RE: Draft Permit to Construct for ROXUL USA, Inc., RAN Facility  
Ranson, Jefferson County  
Permit Number R14-0037-00108

EPA Comments on  
Draft Permit Number R14-0037-00108  
ROXUL USA, Inc

**Comments on the Prevention of Significant Deterioration (PSD) Modeling Report:**

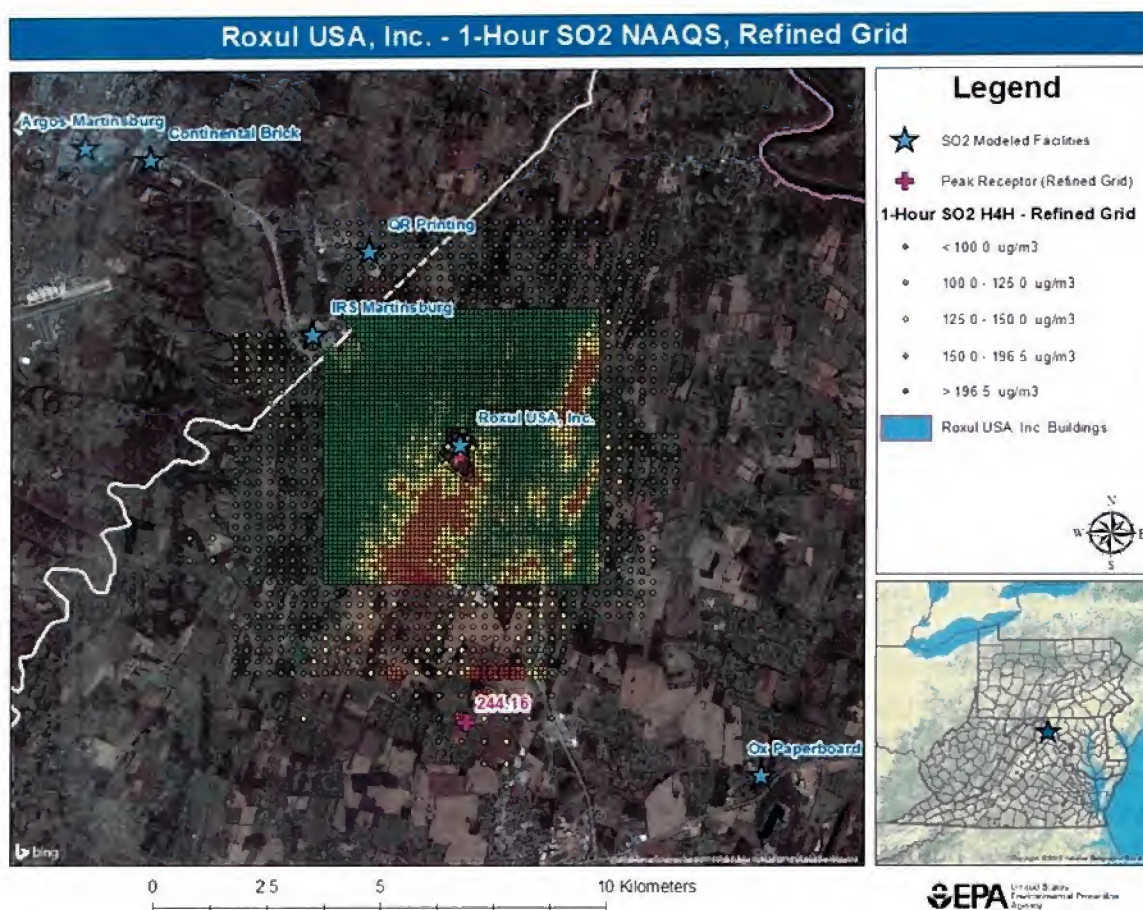
**Modeled 1-Hour SO<sub>2</sub> Violations:** The modeling analysis provided as part of the application contains modeled violations of the 1-hour SO<sub>2</sub> NAAQS. Additional modeling indicates that the primary source contributing to these modeled violations is a coal-fired boiler that is operated by Ox Paperboard near Ranson, WV. Roxul is located approximately 10 km northwest of Ox Paperboard and the modeled violations occur approximately 6-9 km west-northwest of Ox Paperboard; the peak model receptor's high fourth-high values occur during hours when winds are from the east-southeast direction.

WV DEP's modeling analysis demonstrates that Roxul does not significantly contribute to any of the modeled 1-hour SO<sub>2</sub> NAAQS violations and can proceed through the permitting process. EPA Region 3 highly recommends changes be made to the modeling analysis to determine the validity of the modeled 1-hour SO<sub>2</sub> NAAQS violations. Along this line we recommend the following refinements to potentially lower the final modeled 1-hour SO<sub>2</sub> concentrations:

**Use a more refined background concentration:** Instead of using a three (3) year design value, WV DEP should consider using an hour of day or a seasonal hour of day background

concentration as described in EPA's March 1, 2011 Clarification Memo<sup>1</sup>. Using the 99% average by hour of day versus a design value will reduce the background concentration by 6-9 ppb. These values are available upon request from EPA Region 3. WV DEP should also consider using the most recent 2015-17 values for the background monitor if they are available.

**Refine the hourly emission rate for Ox Paperboard's coal-fired boiler:** Ox Paperboard's Title V permit lists the maximum hourly emission rate for this unit as 277.78 lbs/hr. The unit is permitted to operate using a Dry Sorbent Injection or DSI system to control SO<sub>2</sub> emissions. Additional limits include SO<sub>2</sub> emissions not to exceed 484.50 tons per year, hourly coal consumption not to exceed 4.3 tons nor more than 15,000 tons per year and coal sulfur content limits that cannot exceed 1.7% by weight<sup>2</sup>. The NAQS modeling analysis used 35 g/s as Ox Paperboard's hourly SO<sub>2</sub> emission rate, which is 277.7825 lbs/hr using the National Institute of Standards and Technology or NIST conversion rate<sup>3</sup>.

WV DEP should determine if Ox Paperboard's modeled emission rate can be lowered to reflect actual operations or limits in its Title V permit. For example, an average hourly SO<sub>2</sub> emission rate based on the unit's annual SO<sub>2</sub> limit of 484.50 tons would yield an hourly emission rate of approximately 110.62 lbs/hr. Using this annual limit and assuming the maximum permitted hourly rate, the unit would need to cease operations after a little over eight (8) months of continuous operations. If Ox Paperboard continuously operates this unit and complies with its Title V permit then the unit most likely emits well under its maximum hourly permitted rate. EPA estimates the hourly emission rate based on the unit's coal sulfur content restrictions is approximately 146.2 lbs/hr; at this hourly rate the unit would need to cease after nine (9) months of continuous operations.

In accordance with Table 8-2 of EPA's Appendix W, off-site emission rates (for sources such as Ox Paperboard) can be based on the most recent two (2) years of operations. EPA has estimated some of the possible hourly emission rates based on Ox Paperboard's Title V permit. WV DEP should determine if Ox Paperboard's coal-fired boiler emission rate can be further refined based on its most recent two (2) years of operations, its current Title V permit limits or possibly using recent stack testing information. In reality, Ox Paperboard's coal-fired boiler's hourly emission rate is probably less than 150 lbs/hr or 18.9 g/s. Using this value instead of 35 g/s would reduce the final modeled 1-hour SO<sub>2</sub> concentration from 244 µg/m<sup>3</sup> to approximately 150 µg/m<sup>3</sup>, which is well below the 1-hour SO<sub>2</sub> NAAQS.
